SCOPE OF CHANGE FOR THE 40,000 BPSD ASPHALT REVAMP

TITLE PROCESS FLOW DIAGRAM PLANT NO. 1 CRUDE FRACTIONATION PREHEAT TRAIN		DEPARTMENT
AREA NO.	CLASS NO.	PROJECT NO. 10632/10543
DATE	SCALE

DESIGNED BY J.P./R.S.	CHECKED BY R.S.	SECTION NO.	PAC. NO.	REV. 111-SK-2 SHEET 1 OF 4	DATE 1BB
--------------------------	--------------------	-------------	----------	----------------------------------	-------------

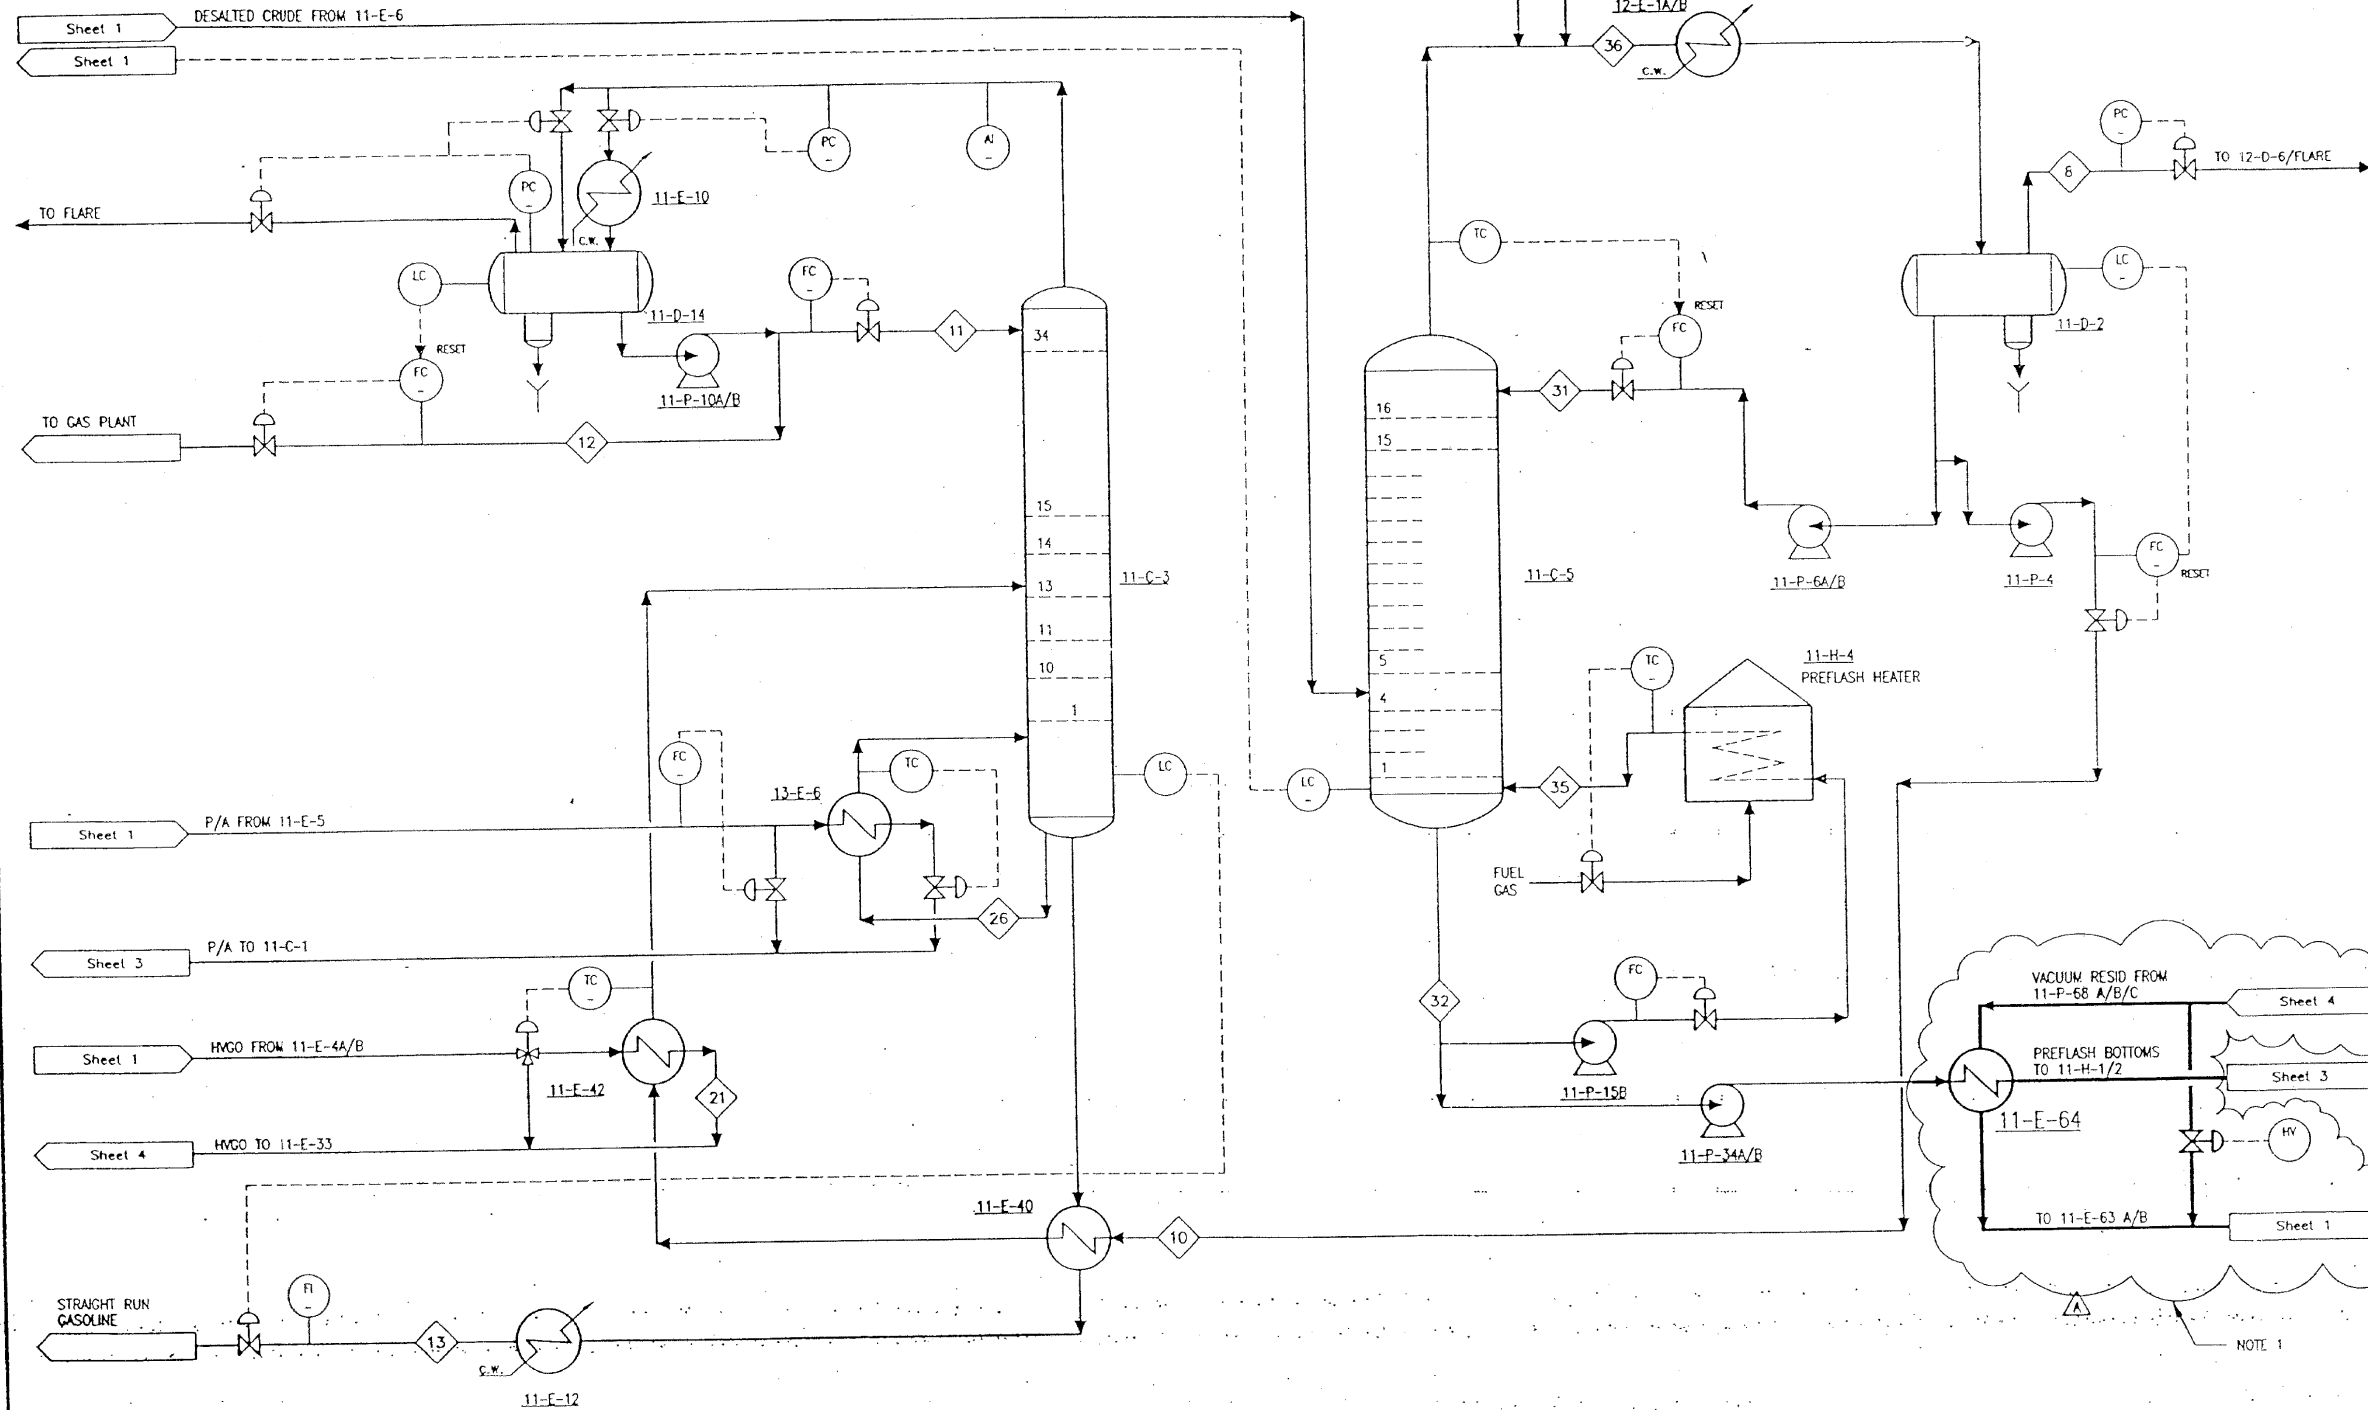
- REMOVE 11-E-3 AND REPLACE WITH THE TWO SHELL 11-E-63. PROVIDE A TEMP. CONTROL BYPASS.
- MANIFOLD THE OUTLET LINES OF THE TWO PARALLEL EXCHANGERS (E-43, E-64) AND THEIR BYPASS.
- REMOVE A SECTION OF THE 6" VACUUM RESID. HEADER.

- DELETED.
- DELETED.
- DELETED.
- REPLACE EXISTING CONTROLLER WITH AGAR ENERGY ABSORPTION PROBE.

111-SK-2
SHEET 2 OF 4

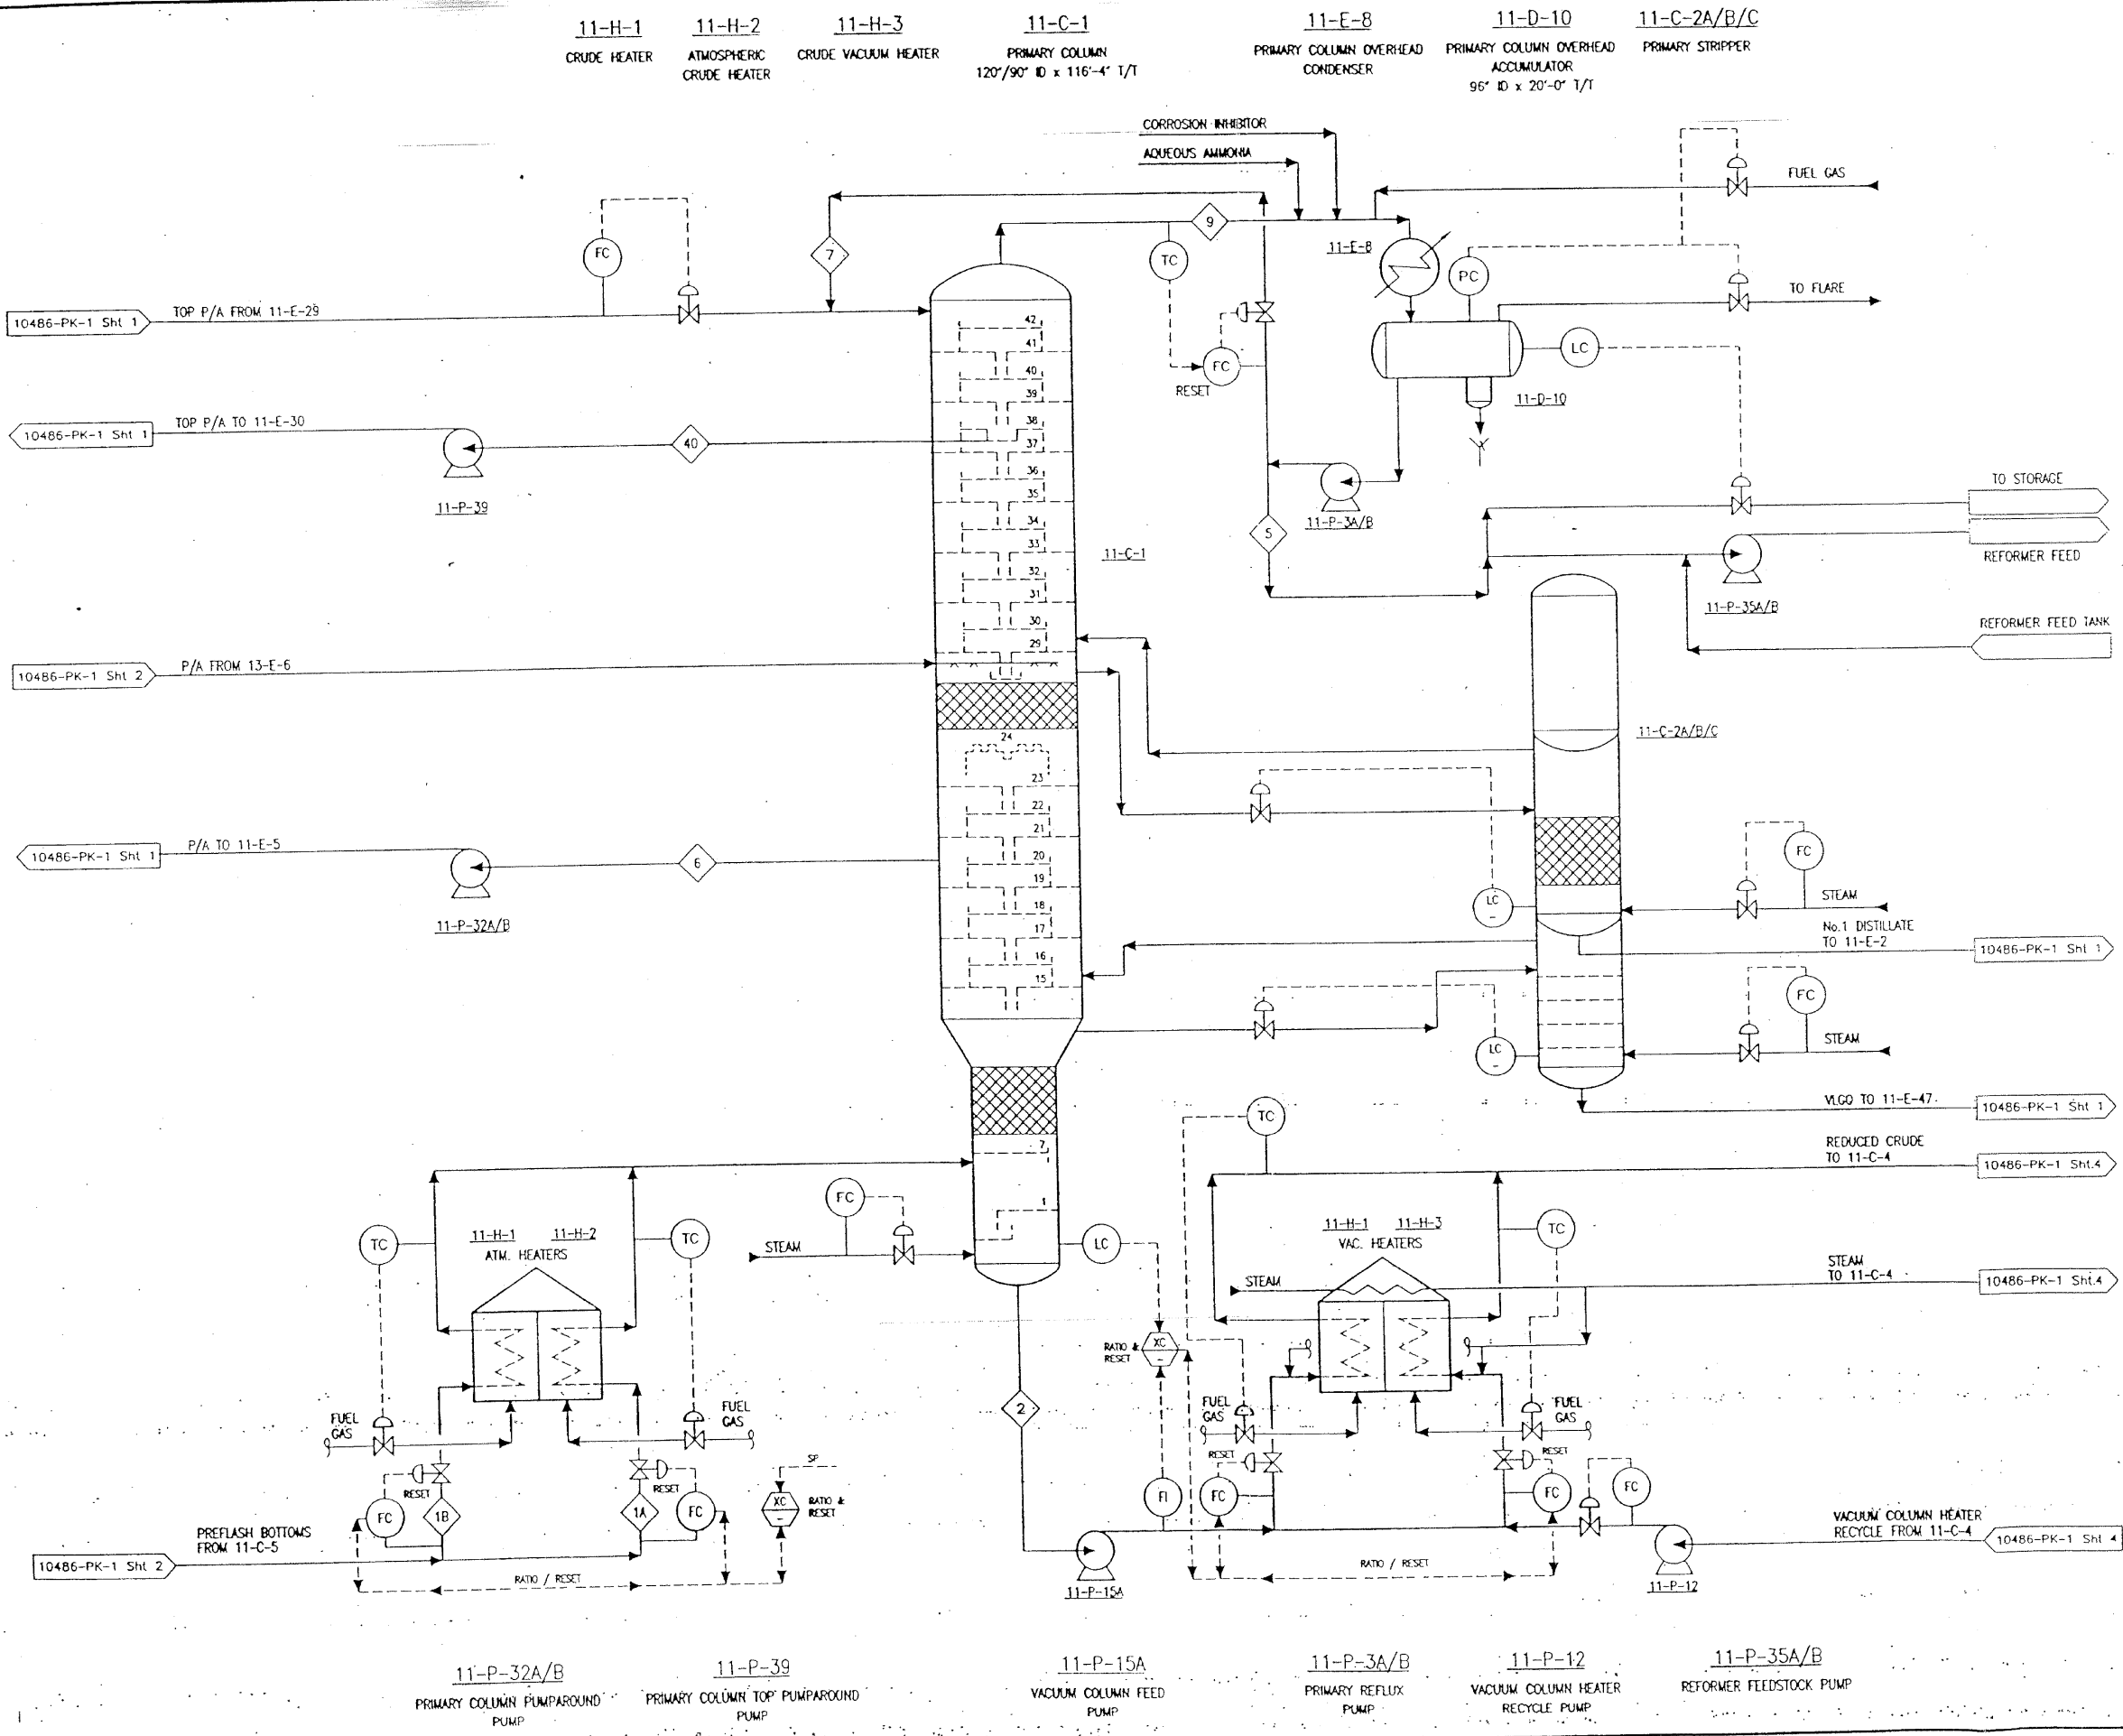
NOTE 1. - INSTALL A NEW ONE SHELL EXCHANGER, 11-E-64
IN THE PREFLASH BOTTOMS STREAM, UPSTREAM OF
THE ATMOSPHERIC HEATERS 11-H-1 AND 11-H-2
AND BYPASS.
